PD Modification Application: MM 24-0933

1.0 APPLICATION SUMMARY

AGENCY REVIEW COMMENT SHEET

PETITION NO: MM 24-0933

Limits of Construction – End of Pavement to just east of planned project driveway
(300 feet)

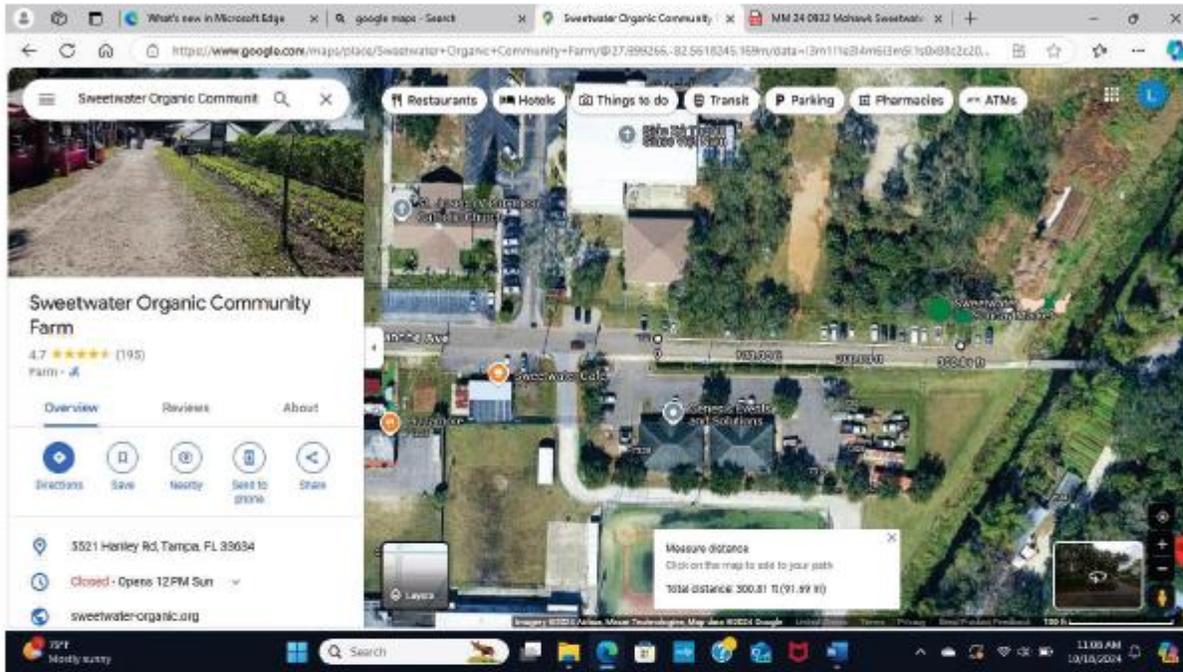
PROPOSED IMPROVEMENTS – A modified TS-7 is proposed, as is shown in the Typical Section Exhibit from the end of asphalt pavement to just east of the project driveway, as shown in the Project Limits Exhibit, a distance of 300 feet (the total length of proposed improvements). The roadway will be improved, but not brought fully to TS-7 standards because a standard TS-7 section would require 96 feet of right of way. No right-of-way dedication will occur with this project. The existing 12 foot lanes will be extended to reconstruct the segment that is currently gravel.

DRAWING NO. TS-7
SHEET NO. 1 OF 1

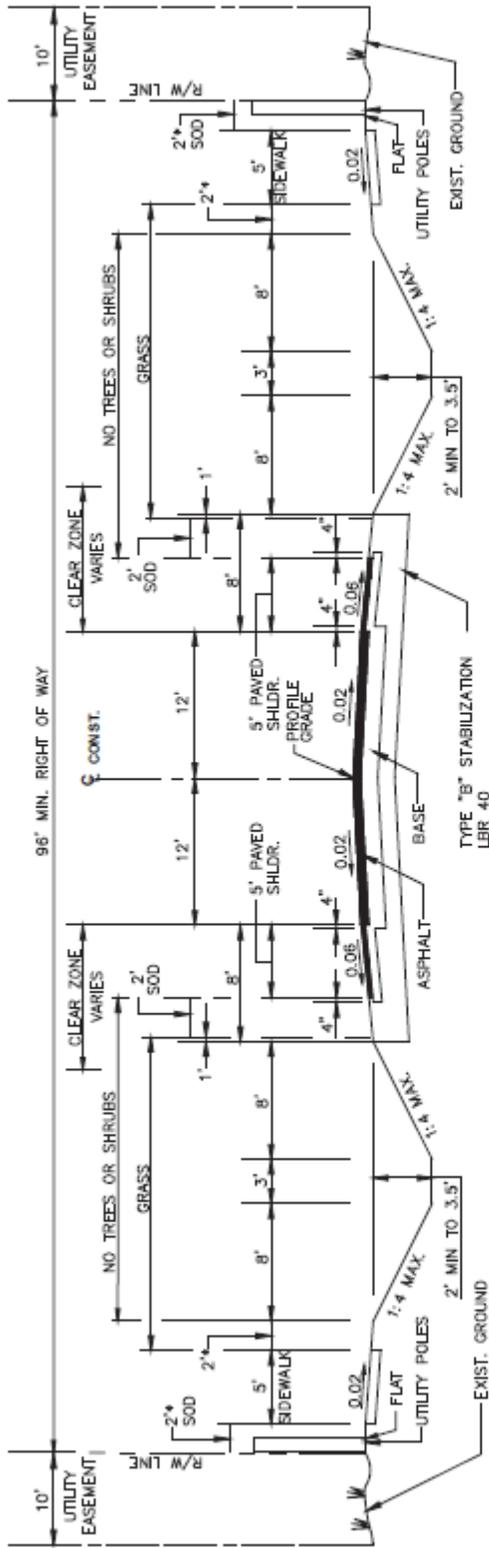
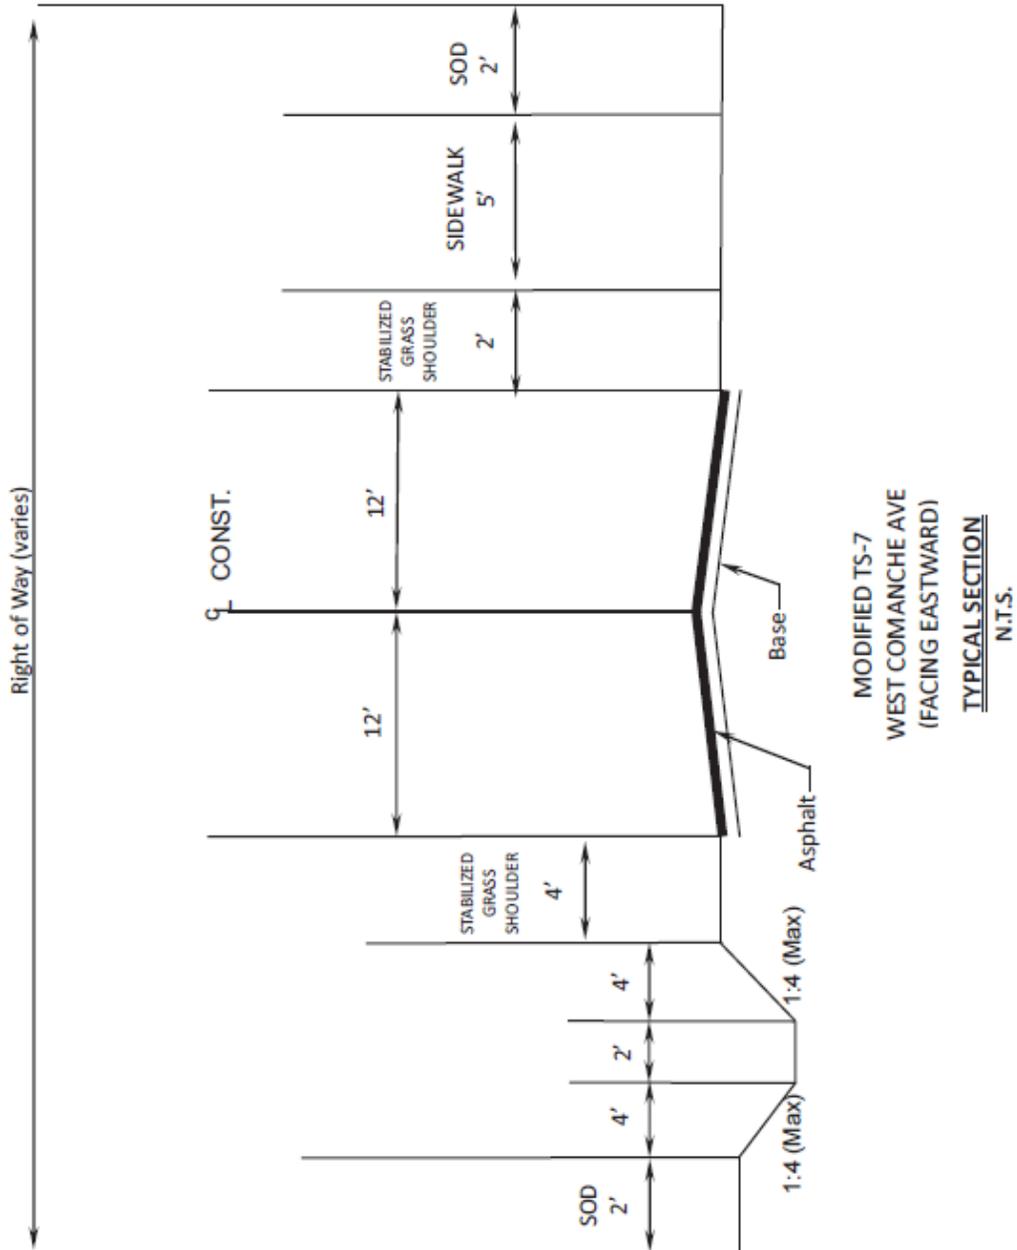
As W Comanche Ave is a substandard local roadway, the applicant's Engineer of Record (EOR) submitted a Design Exception request (dated November 3, 2024) to determine the specific improvements that would be required by the County Engineer. Based on factors presented in the Design Exception request, the County Engineer found the request approvable (on November 5, 2024). The deviations from the Hillsborough County Transportation Technical Manual (TTM) TS-7 Typical Section (for 2-lane Urban Roadways) include:

- Stabilized grass shoulders are proposed, rather than paved shoulders.
- The ditches and clear zone are narrower than TS-7 (See proposed TS) because there is not enough right-of-way to construct them at full-width, and because of the placement of the existing sidewalk on south side relative to the travel lanes.

- No bike lanes are proposed to be constructed.
- No sidewalk is proposed on the north side.
- 44 feet of right-of-way (existing) versus 96 feet of right-of-way required for Hillsborough County TS-7

If 24-0933 is approved, the County Engineer will approve the Design Exception request.
